September 21, 2018

**RE: South Bellevue Segment Energize Eastside – Response to Technical Review Letter, Part 1  
Conditional Use (File# 17-120556-LB)  
Critical Areas Land Use Permit (File #17-120557-LO)**

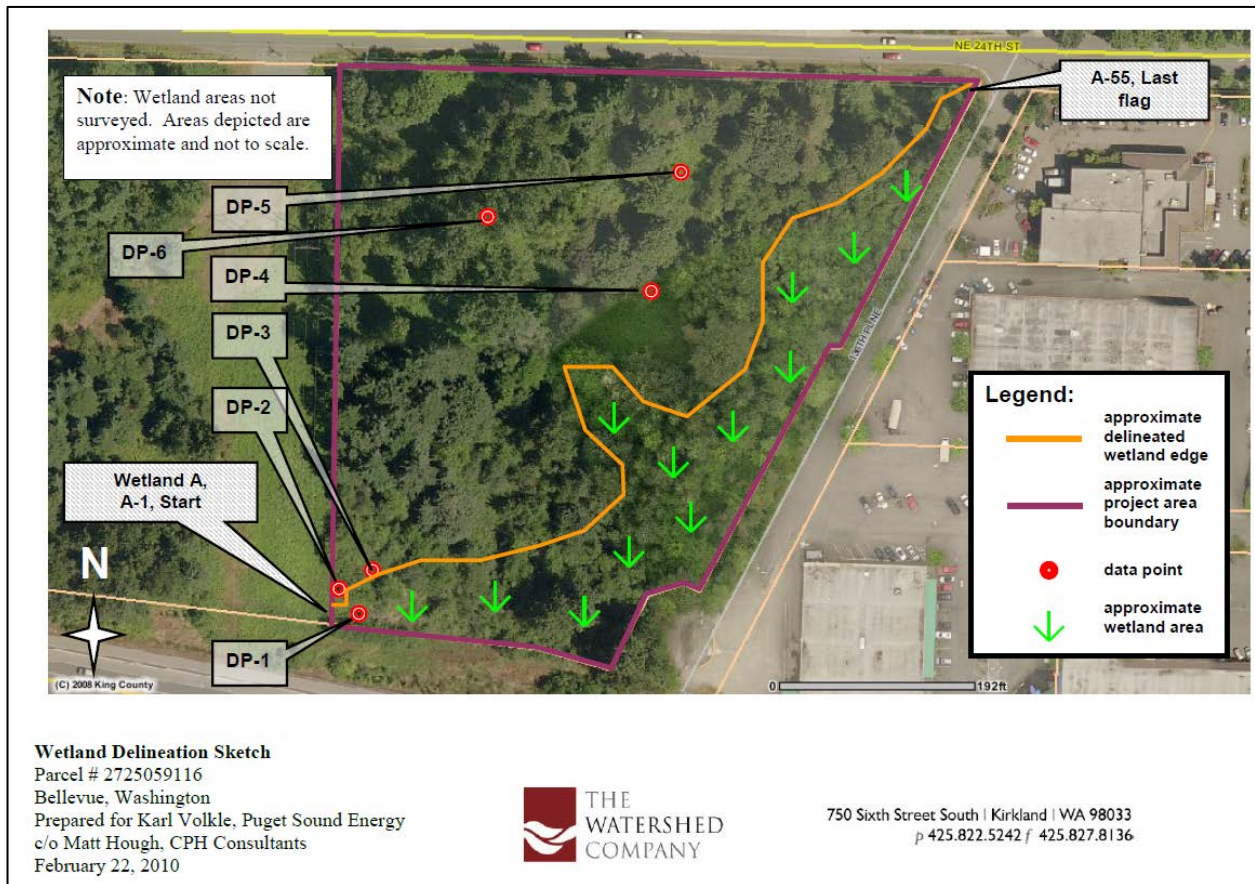
**Lakeside-Goodes Corner 115kV Line:** In the vicinity of the Lakeside and new Richards Creek substations, the Lakeside-Goodes Corner line is currently on double circuit structures with the existing Talbot Hill-Lakeside #1 line (which will be upgraded to 230 kV). When the existing Talbot Hill-Lakeside #1 and #2 115 kV lines are upgraded to 230 kV as part of the Energize Eastside project, they will be attached to the south side of the new Richards Creek substation; therefore the Lakeside-Goodes Corner line will require new poles to support it. Starting at Lakeside Substation the Lakeside-Goodes Corner line will be moved to the east on steel poles (similar to the C-17 pole type) and cross under both the Richards Creek-Lakeside 115 kV line and the Sammamish-Richards Creek 230 kV #2 line (west circuit). As the Lakeside-Goodes Corner line travels south, it will be relocated west of its existing location for the length of the Richards Creek substation. At the southern limit of the Richards Creek substation, the Lakeside-Goodes Corner line will turn to the southeast for one span and cross under the Sammamish-Richards Creek 230 kV #2 line and the Talbot Hill-Richards Creek 230 kV #1 and #2 lines before proceeding due south. Between poles 8/10 and 9/1 on the Talbot Hill-Richards Creek 230 kV #1 line a new wood pole will be installed for the Lakeside-Goodes Corner line to facilitate keeping it within the existing easement. From this point, the Lakeside-Goodes Corner line will be co-located with the Talbot Hill-Richards Creek 230 kV #1 line on poles 8/9 and 8/10. As the Lakeside-Goodes Corner line continues south it crosses I-90, where it makes a 90 degree turn to the east. At the 90 degree turn south of I-90, this line will be placed on a new steel pole located east of Talbot Hill-Richards Creek 230 kV #1 line, pole 8/8 (eastern circuit).
